SUBJECT: Consideration of tentative approval of the request of Pulte Homes of Michigan, LLC, for Emerson Park, JSP 17-10, with Zoning Map Amendment 18.717, to rezone property in Section 22, located on the west side of Novi Road between Ten Mile Road and Grand River Avenue from OS-1, (Office Service) to RM-2 (High Density Multiple Family Residential) subject to a Planned Rezoning Overlay (PRO) Agreement, and corresponding PRO Concept Plan. The property totals approximately 24 acres and the applicant is proposing a 120-unit multiple-family attached condominium development.

SUBMITTING DEPARTMENT: Community Development Department – Planning *Barb*

CONCEPTUAL PLANNED REZONING OVERLAY (PRO)

sheet no.:
LS-1 of 6

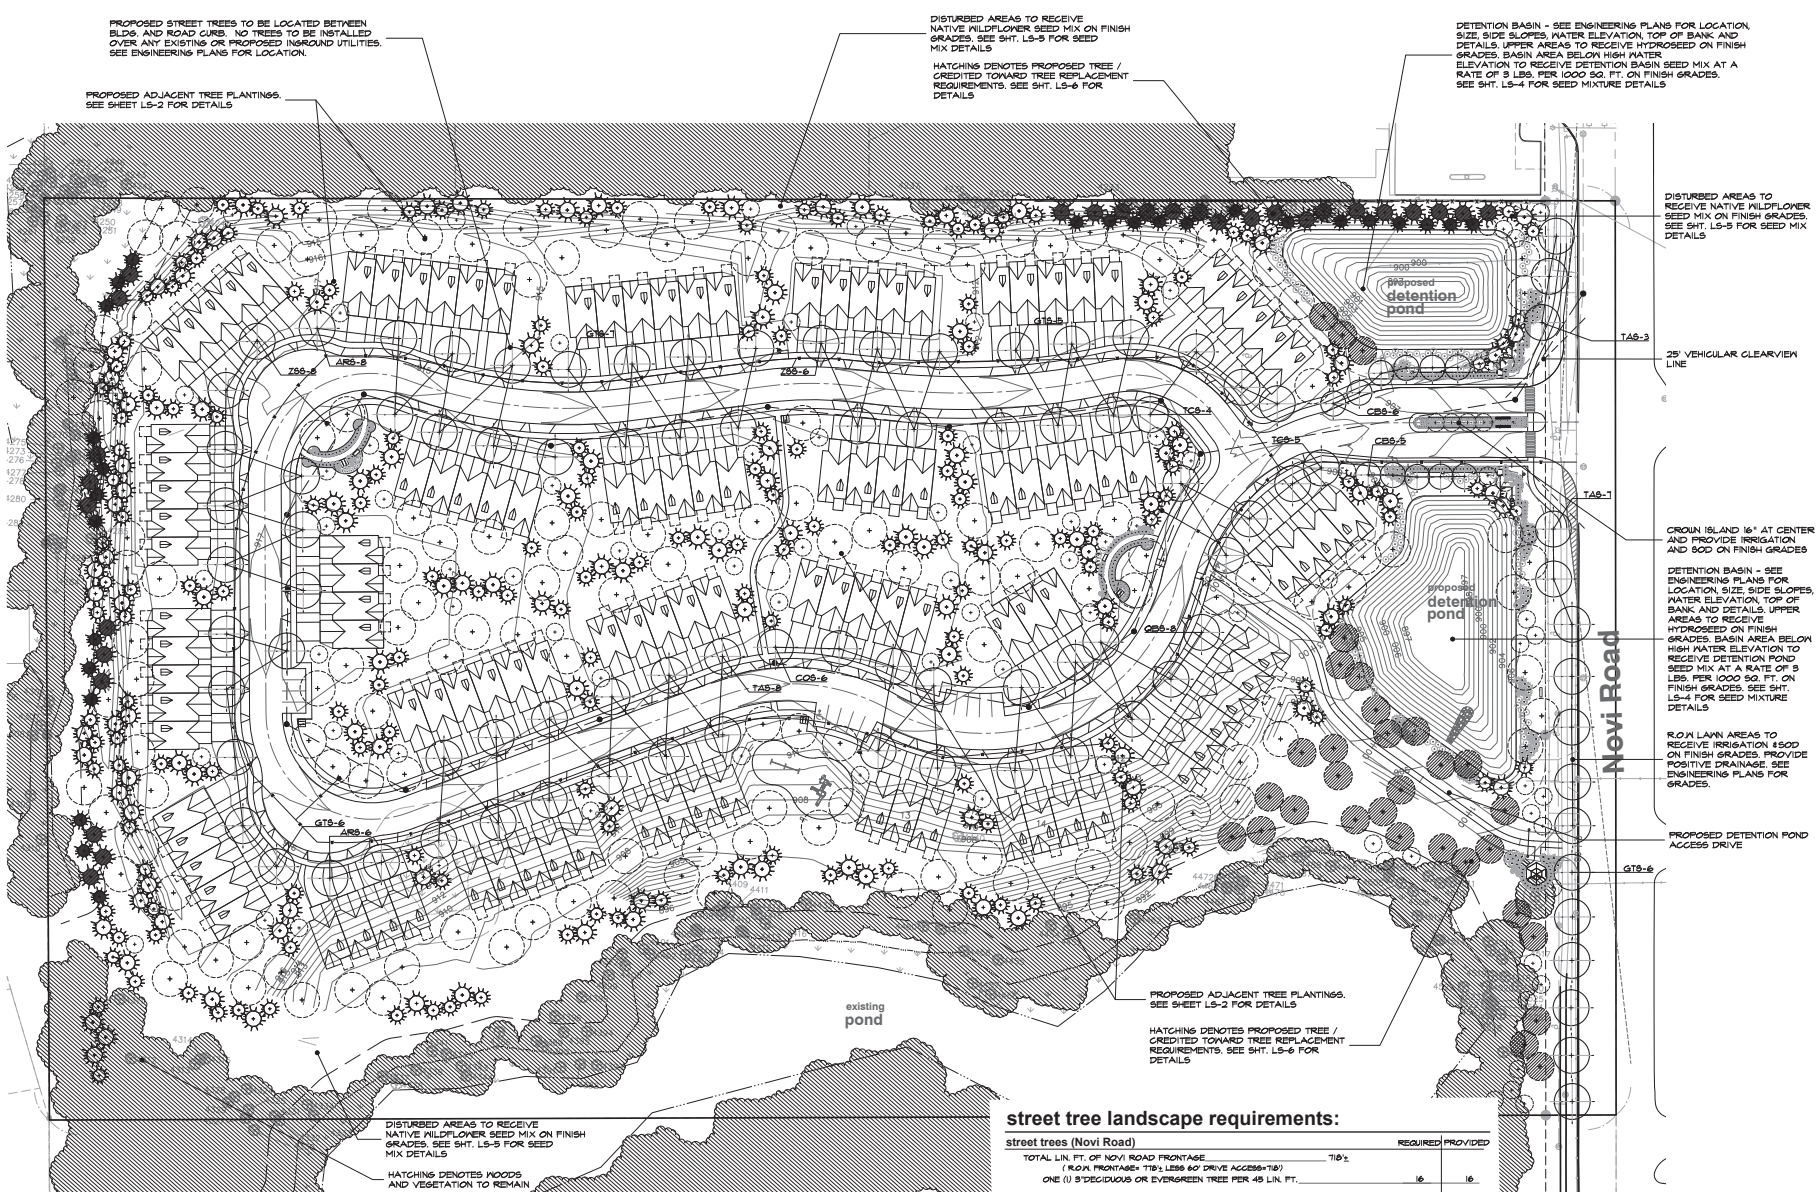
4. There is a contradiction between the two figures used as a basis for the street trees calculations. 3349 lf is shown as the basis, but the calculations show the number to be 2821 lf. The latter figure was used for the tree requirement. **Please use the correct number as the basis and remove the incorrect figure from the calculations. If the correct figure is 2,080 lf, then more than the required number of street trees is provided.**

Figure 1. City of Novi Regulated Wetland & Woodland Map (approximate project area is highlighted in red). Regulated Woodland areas are shown in green and regulated Wetland areas are shown in blue).

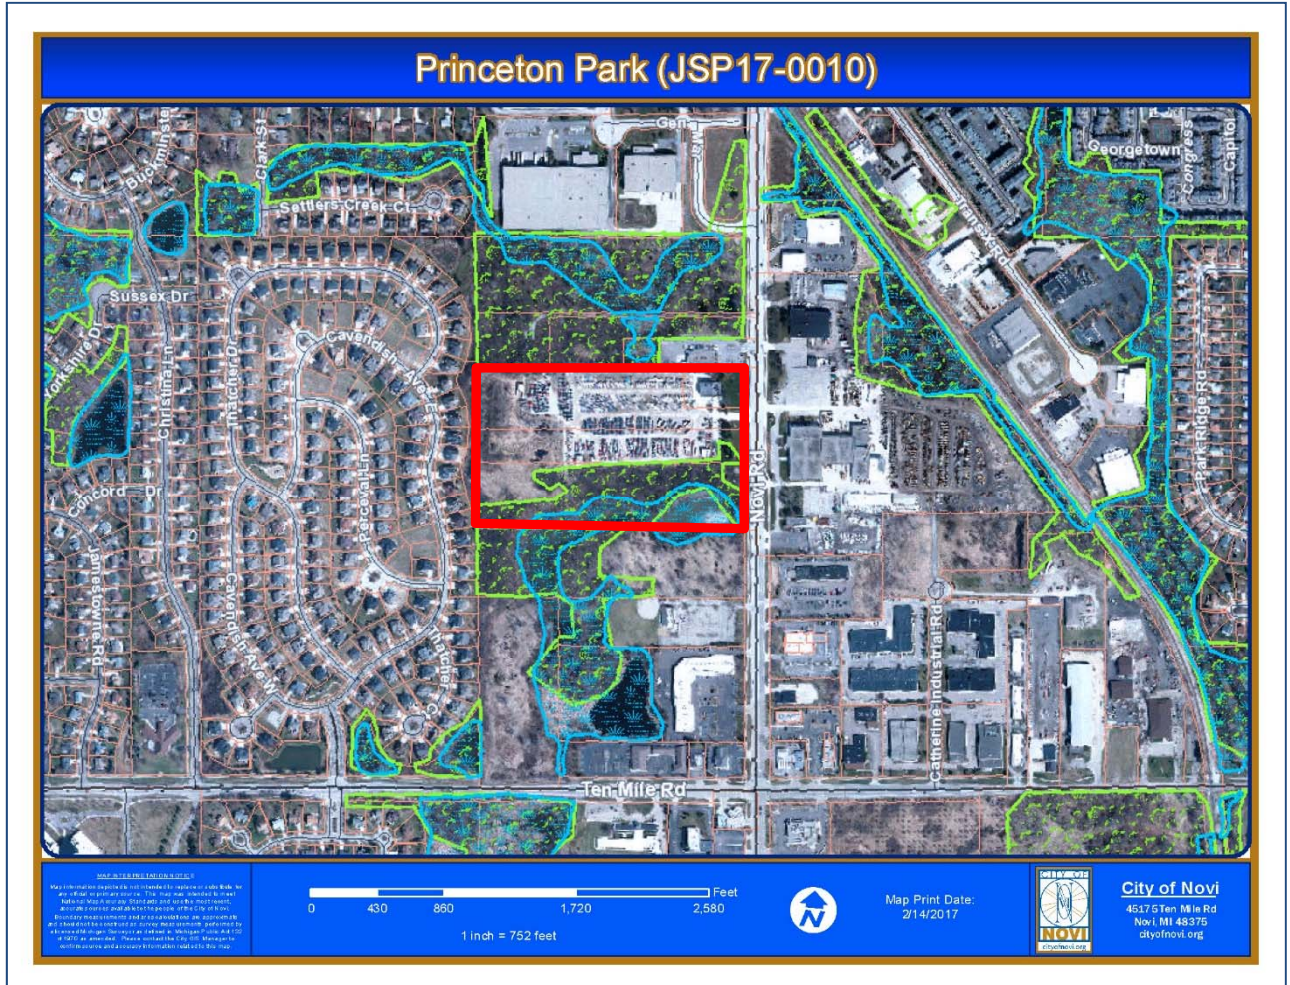
Based on our review of the Plan, Novi aerial photos, Novi GIS, the City of Novi Official Wetlands and Woodlands Maps (see Figure 1, attached) it appears as if this proposed project site contains City-regulated wetlands and woodlands. The City's wetland and woodland map shows that the overall property contains wetlands to the south. However, a review of aerial photos of the site and the proposed site plan, the site contains three (3) areas of wetland (Wetlands #1, #2, and #3), along both the southern and western portion of the site.

As noted, three (3) areas of wetland exist on this parcel (Wetland #1, #2, and #3). The proposed site development appears to be partly designed around the existing on-site wetland and 25-foot wetland setback areas. The *Layout Plan* (Sheet 05) indicates that the proposed development will impact Wetland #3 and the storm water outlet is currently planned to be directed to the 25-foot setback of Wetland #1, in the southeast portion of the site. The following table summarizes the existing wetlands and the proposed wetland impacts as shown on the Plan:

Figure 1. City of Novi Regulated Wetland & Woodland Map (approximate project area is highlighted in red). Regulated Woodland areas are shown in green and regulated Wetland areas are shown in blue).

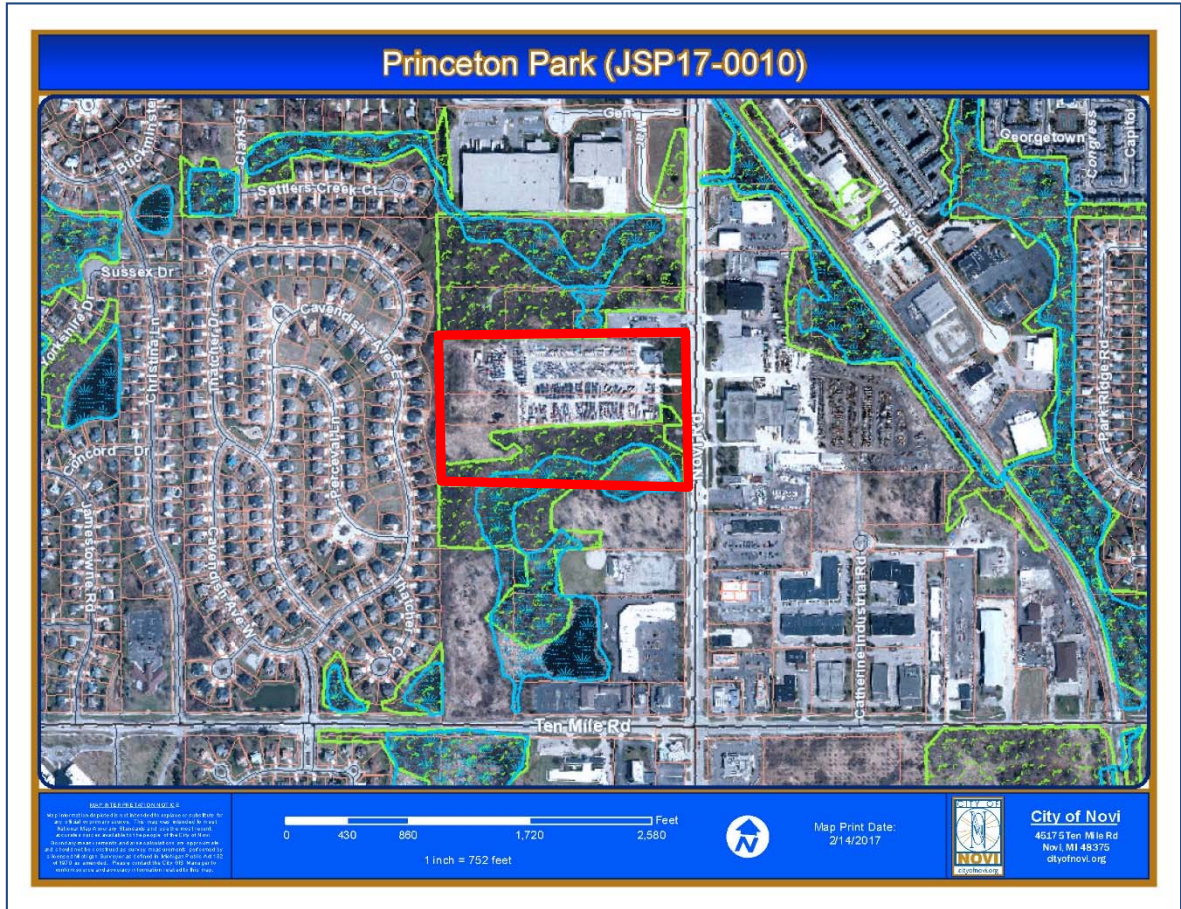
ECT completed an on-site woodland evaluation on Tuesday, February 21, 2017. As noted above, the site does contain area designated as City of Novi Regulated Woodland. A significant portion of the proposed limits of disturbance for the project is located outside of the areas mapped as City Regulated woodland (see Figure 1). The

majority of the Regulated Woodland area is located on the southern portion of the project site (see Figure 1). Tree survey information has been provided on the *Tree List* plan (Sheet 03). This sheet includes a tree list that indicates the proposed woodland impacts and required Woodland Replacement tree credits for these removals. The Plan indicates that a total of 328 trees have been surveyed for the project. Of the trees surveyed, 262 trees are located within the area designated as Regulated Woodland (80% of the surveyed trees are located within the regulated woodland area). Fifty percent (50%) of the surveyed trees are comprised of the following tree species:
